ENGINEERING CHANGE NOTICE

Proj. ECN B-714-24

BLOCK 5: B-714, GROUT VAULT PAIR (218-E-16-102 & 103) (218-E-16-104 & 105) / ER8007
BLOCK 6: 218-E-16-102 & -103 and 218-E-16-104 & -105
BLOCK 9: ECN B-714-7, -9, -10, -15, -19, -20
BLOCK 8: SPECIFICATION B-714-C2, ~~REV 0~~ 2-7-90 (V-B714C2-003, REV 0) SEE PAGE 9 & 10

VAULTS 218-E-16-102 & 103
CIVIL/STRUCTURAL CHANGES TO DRAWINGS

KAISER ENGINEERS HANFORD			ENGINEERING CHANGE NOTICE SKETCH			
Ref. Dwg. H-2-77575	Sh. 2	Rev. 1	Prepared By TERESA EHRHARD	Checked By	ECN No. B-714-24	Page 11/28
H-2-78446	2	0	REF: ECN B-714-19, page 39

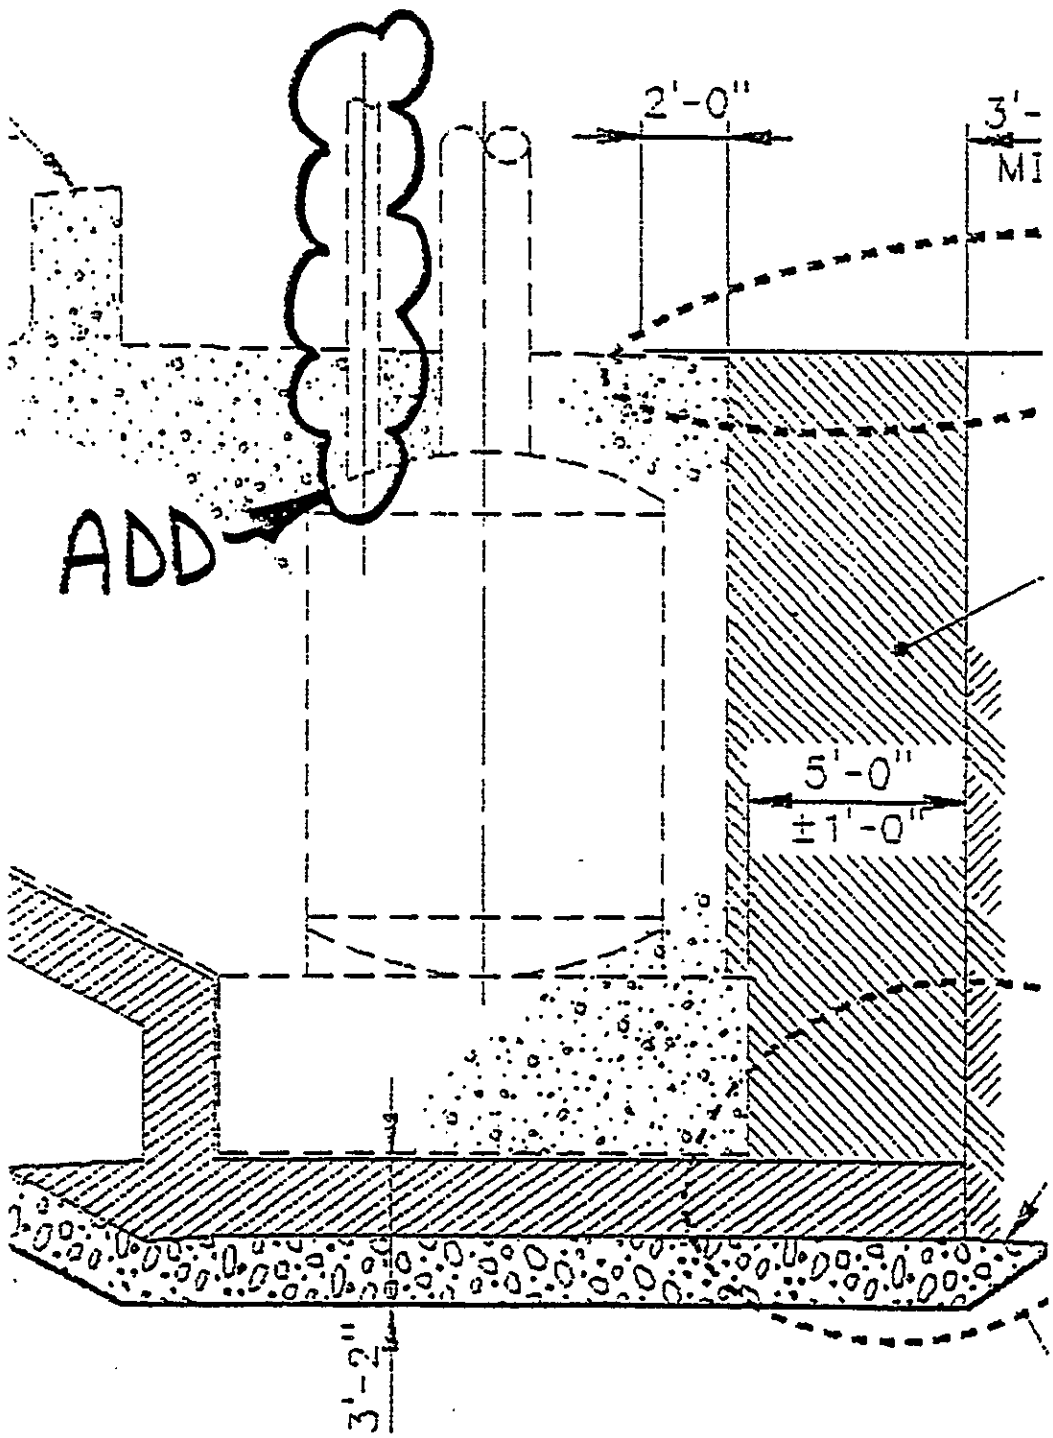
1) H-2-77575, SH 2, REV 1
SECTION C (ZB4): Modify - see page 11 of this ECN.

29) H-2-78446, SH 2, REV 0
SECTION C (ZC3): Modify - see page 11 of this ECN.

KAISER ENGINEERS HANFORD			ENGINEERING CHANGE NOTICE SKETCH			
Ref. Dwg. H-2-77576	Sh. 1	Rev. 0	Prepared By TERESA EHRHARD	Checked By	ECN No. B-714-24	Page 12/28
H-2-78447	1	0	REF: ECN B-714-19, page 13 (SECTION E)

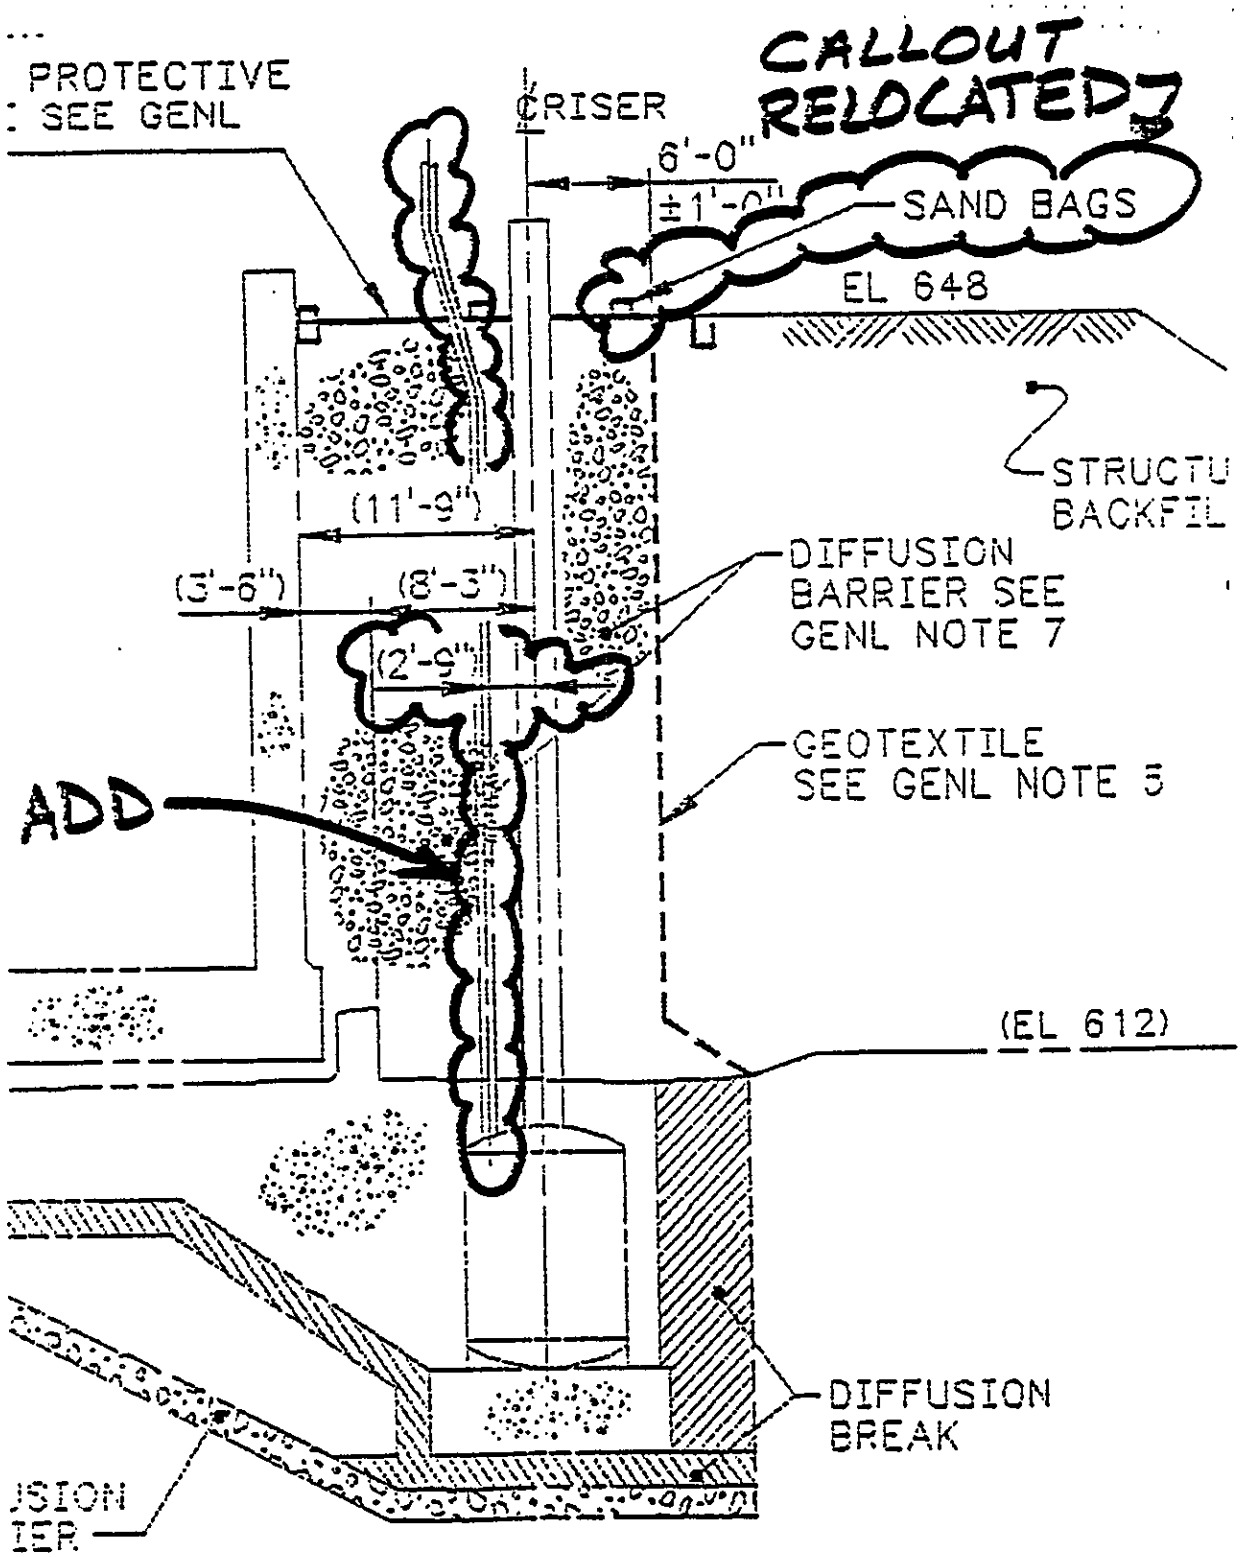
2) H-2-77576, SH 1, REV 0
SECTION E (ZB-C3): Modify - see page 12 of this ECN.

30) H-2-78447, SH 1, REV 0
SECTION E (ZB-C4): Modify - see page 12 of this ECN.

KAISER ENGINEERS HANFORD	ENGINEERING CHANGE NOTICE SKETCH					
Ref. Dwg.	Sh.	Rev.	Prepared By	Checked By	ECN No.	Page
H-2-77578	1	0	TERESA EHRHARD		B-714-24	13/28
H-2-78448	1	0

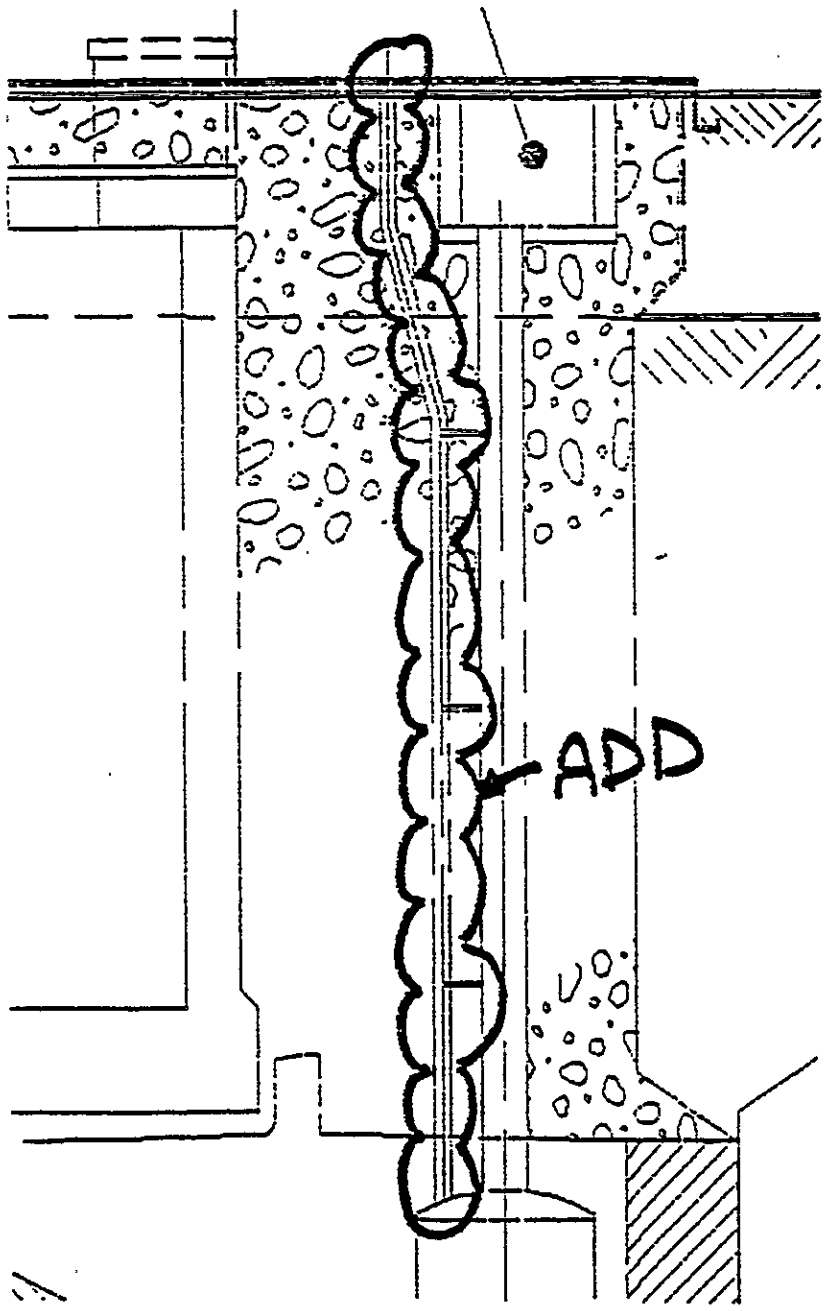
3) H-2-77578, SH 1, REV 0
SECTION B (ZC-D3): Modify - see page 13 of this ECN.

31) H-2-78448, SH 1, REV 0
SECTION B (ZE-F2): Modify - see page 13 of this ECN.

KAISER ENGINEERS HANFORD	ENGINEERING CHANGE NOTICE SKETCH					
Ref. Dwg.	Sh.	Rev.	Prepared By	Checked By	ECN No.	Page
H-2-77587	1	0	TERESA EHRHARD		B-714-24	14/28
H-2-77587	2	0				
H-2-78458	1	0				
H-2-78458	2	0

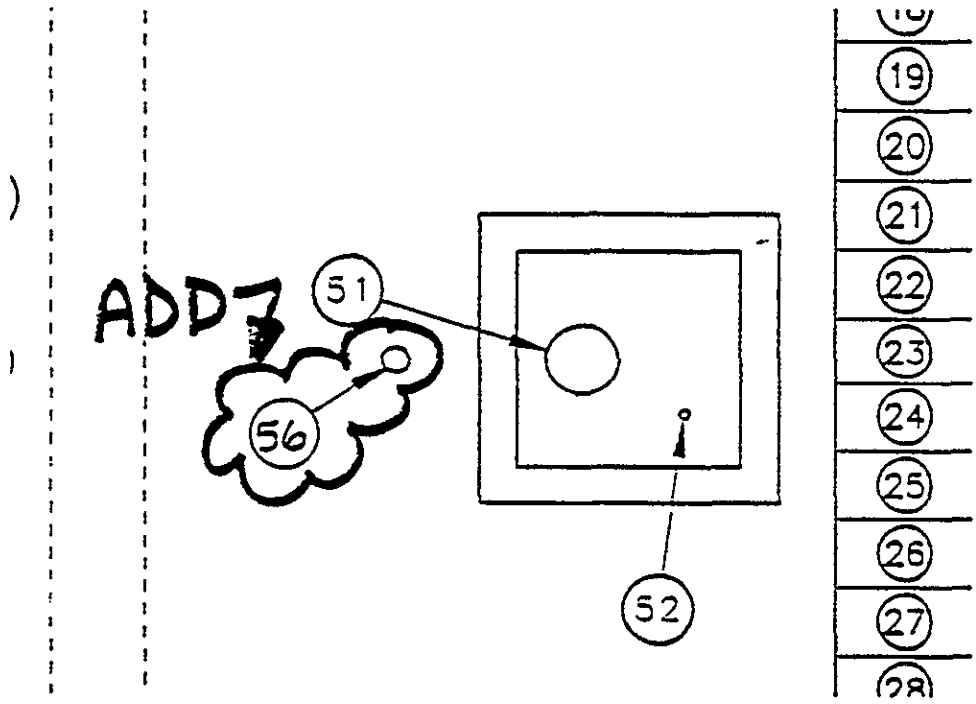
5) H-2-77587, SH 1, REV 0
A) PLAN (ZD3): Modify - see page 14 of this ECN.
B) TABLE (ZB1-2): Add the following riser at end of table:

6) H-2-77587, SH 2, REV 0
A) PLAN (ZD3): Modify - see page 14 of this ECN.
B) TABLE (ZB1-2): Add the following riser at end of table:

34) H-2-78458, SH 1, REV 0
A) PLAN (ZD3): Modify - see page 14 of this ECN.
B) TABLE (ZB1-2): Add the following riser at end of table:

35) H-2-78458, SH 2, REV 0
A) PLAN (ZD3): Modify - see page 14 of this ECN.
B) TABLE (ZB1-2): Add the following riser at end of table:

KAISER ENGINEERS HANFORD	ENGINEERING CHANGE NOTICE SKETCH					
Ref. Dwg.	Sh.	Rev.	Prepared By	Checked By	ECN No.	Page
H-2-77588	1	0	TERESA EHRHARD		B-714-24	15/28
H-2-77588	4	0				
H-2-78459	1	0				
H-2-78459	3	0

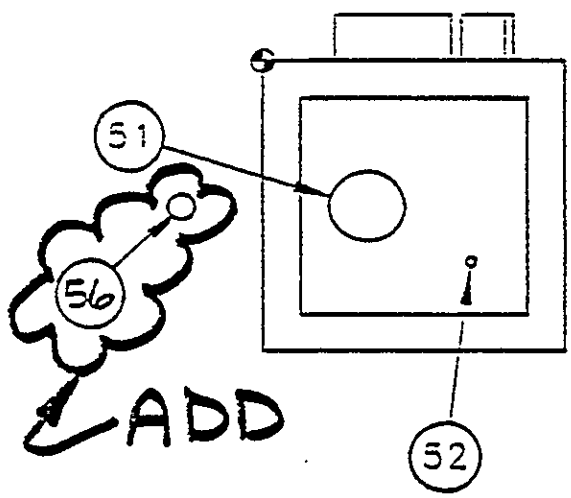
7) H-2-77588, SH 1, REV 0
PLAN (ZD2): Modify - see page 15 of this ECN.

9) H-2-77588, SH 4, REV 0
PLAN (ZD2): Modify - see page 15 of this ECN.

36) H-2-78459, SH 1, REV 0
PLAN (ZD2): Modify - see page 15 of this ECN.

38) H-2-78459, SH 3, REV 0
PLAN (ZD2): Modify - see page 15 of this ECN.

KAISER ENGINEERS HANFORD			ENGINEERING CHANGE NOTICE SKETCH			
Ref. Dwg.	Sh.	Rev.	Prepared By	Checked By	ECN No.	Page
H-2-77593	1	0	TERESA EHRHARD		B-714-24	16/28
H-2-78455	1	0

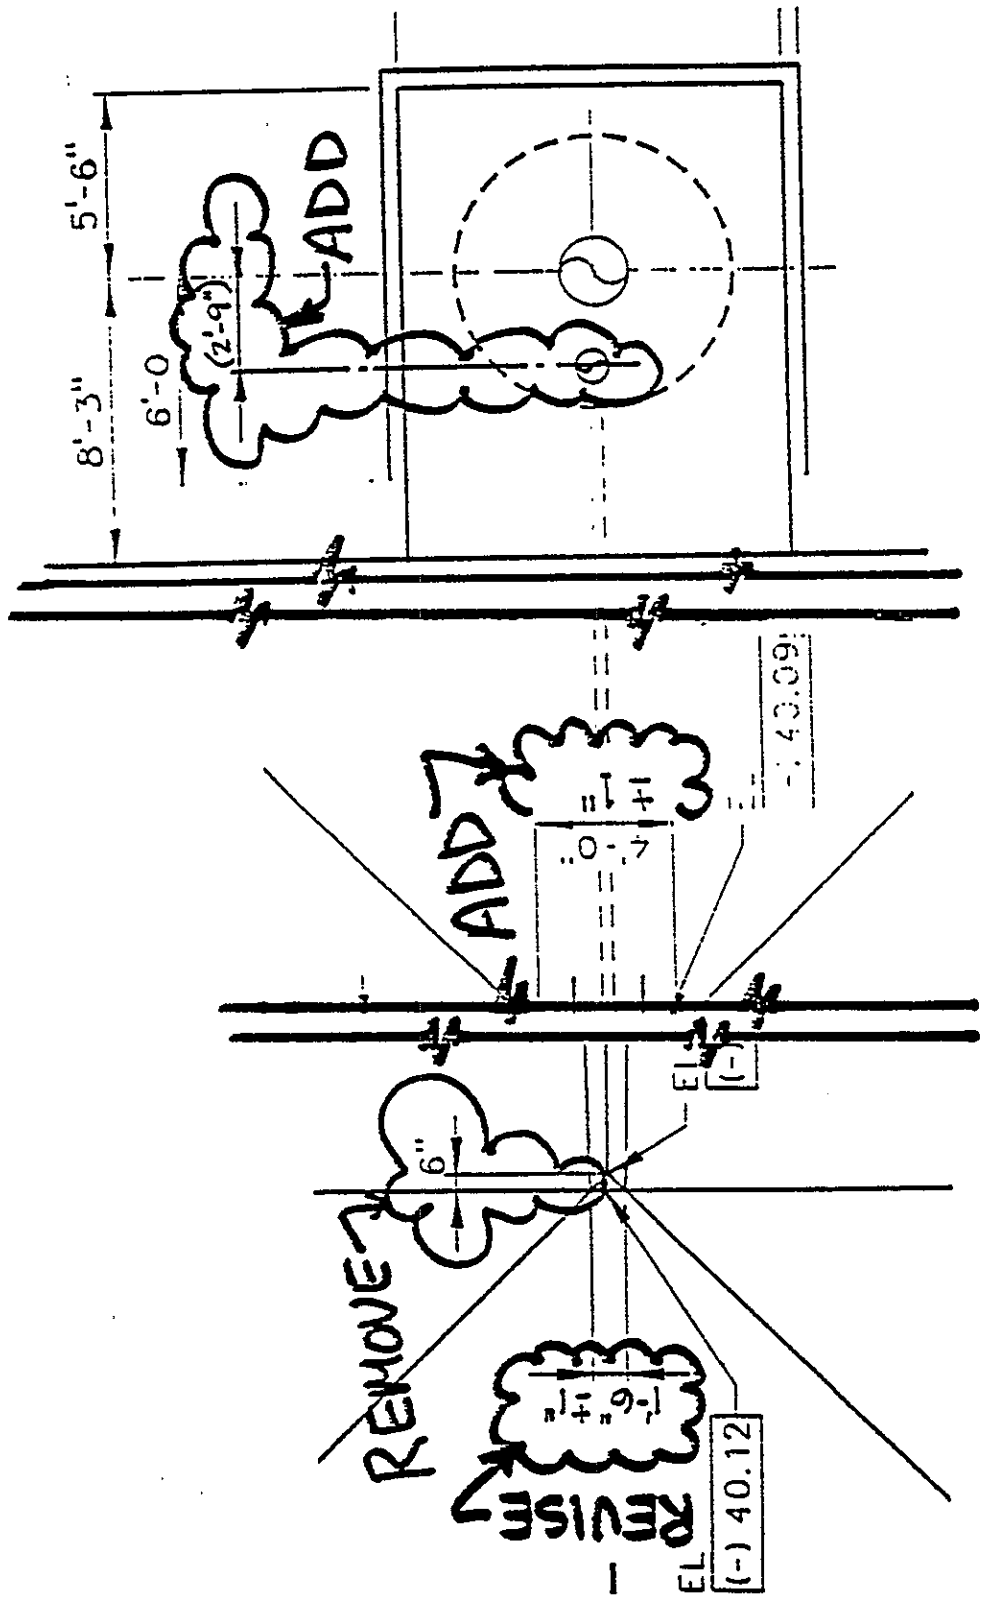
11) H-2-77593, SH 1, REV 0
PLAN (ZD2, D3, D6, E6): Modify - see page 16 of this ECN.

32) H-2-78455, SH 1, REV 0
PLAN (ZD2): Modify - see page 16 of this ECN.

KAISER ENGINEERS HANFORD	ENGINEERING CHANGE NOTICE SKETCH					
Ref. Dwg.	Sh.	Rev.	Prepared By	Checked By	ECN No.	Page
H-2-77593	2	0	TERESA EHRHARD		B-714-24	17/28
H-2-78455	2	0

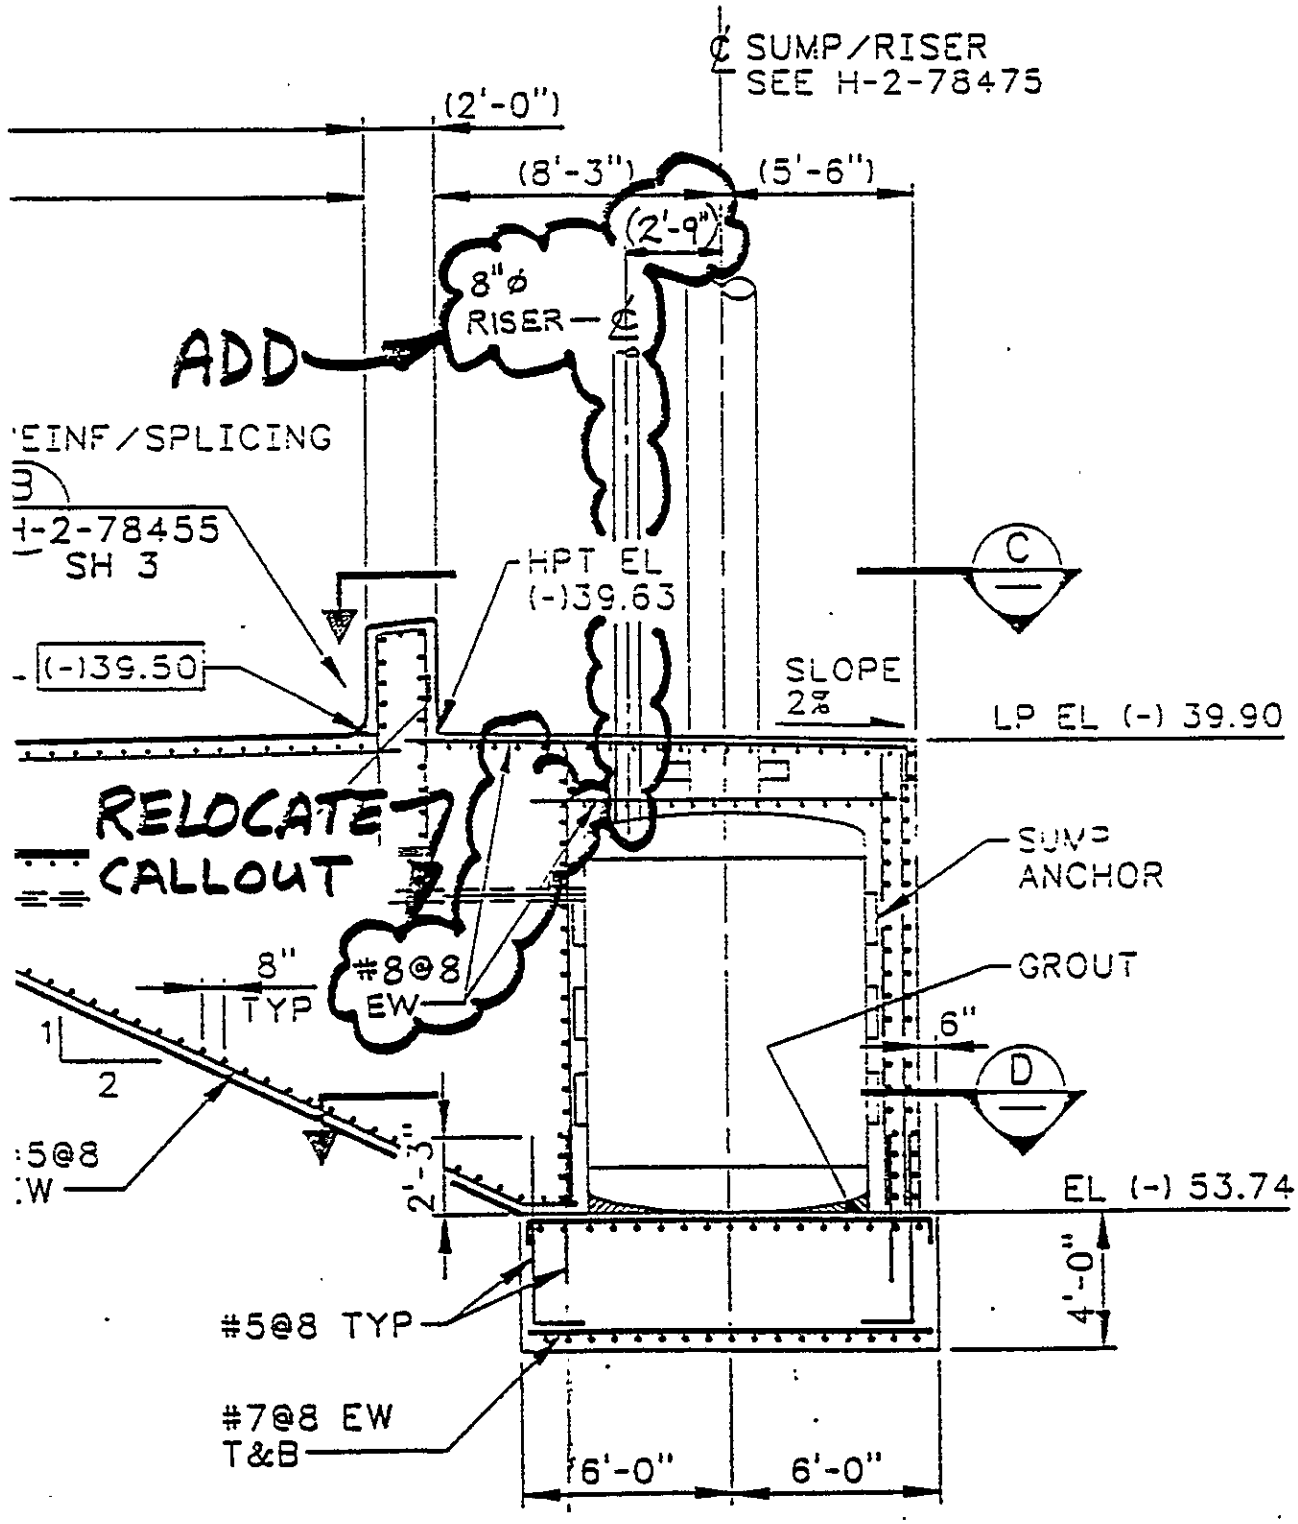
12) H-2-77593, SH 2, REV 0
A) SECTION A (ZE-F3): Modify - see page 17 of this ECN.
B) PLAN C (ZD8): Modify - see page 18 of this ECN.

33) H-2-78455, SH 2, REV 0
A) SECTION A (ZE-F2): Modify - see page 17 of this ECN.
B) SECTION C (ZD7): Modify - see page 18 of this ECN.

KAISER ENGINEERS HANFORD	ENGINEERING CHANGE NOTICE SKETCH					
Ref. Dwg. ECN B-714-19	Sh. 10	Rev. 0	Prepared By STAN SMITH	Checked By	ECN No. B-714-24	Page 19/28
ECN B-714-19	13	0

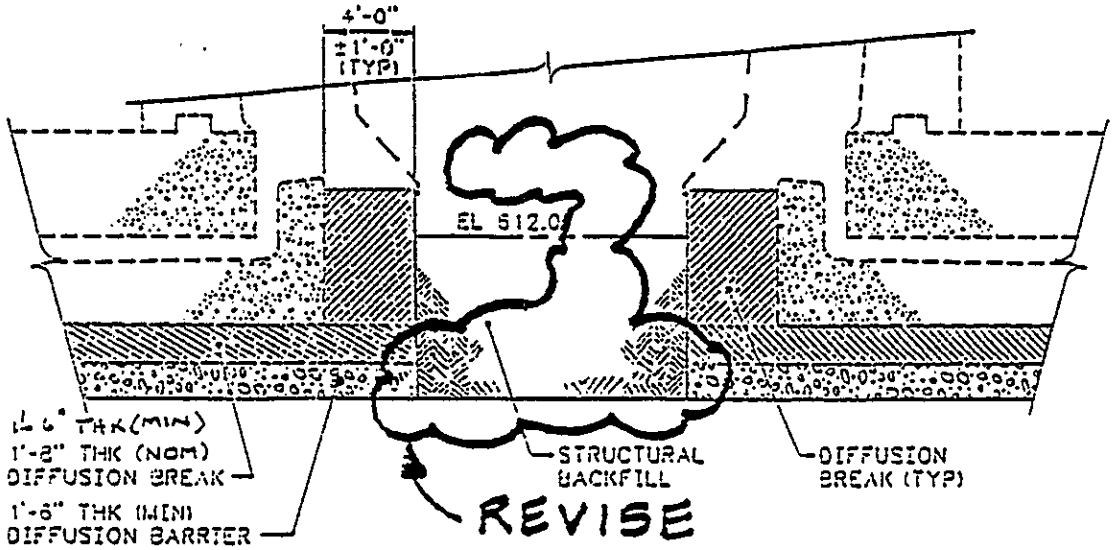
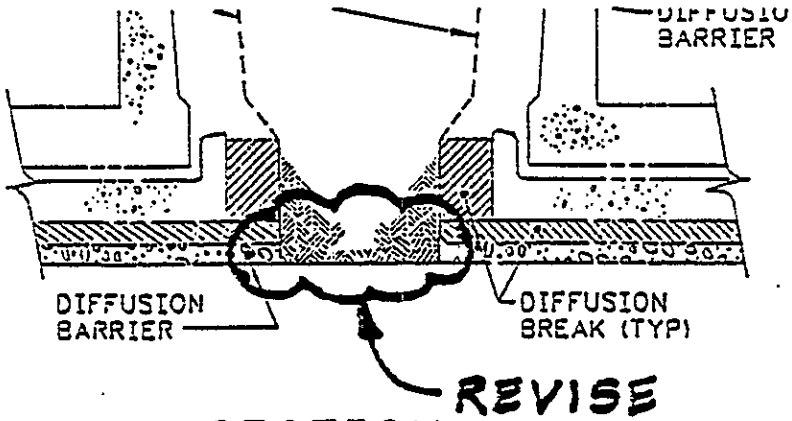
28) ECN B-714-19, PAGE 10, 13 & 14
A) Modify SECTION D - see page 19 of this ECN.
(Ref: H-2-77575, SH 2, REV 1)
B) Modify SECTION D - see page 19 of this ECN.
(Ref: H-2-77576, SH 1, REV 0)
C) Modify SECTION A - see page 20 of this ECN.
(Ref: H-2-77578, SH 1, REV 0)

54) ECN B-714-19, PAGE 10, 13 & 14
A) Modify SECTION D - see page 19 of this ECN.
(Ref: H-2-78446, SH 2, REV 0)
B) Modify SECTION D - see page 19 of this ECN.
(Ref: H-2-78447, SH 1, REV 0)
C) Modify SECTION A - see page 20 of this ECN.
(Ref: H-2-78448, SH 1, REV 0)
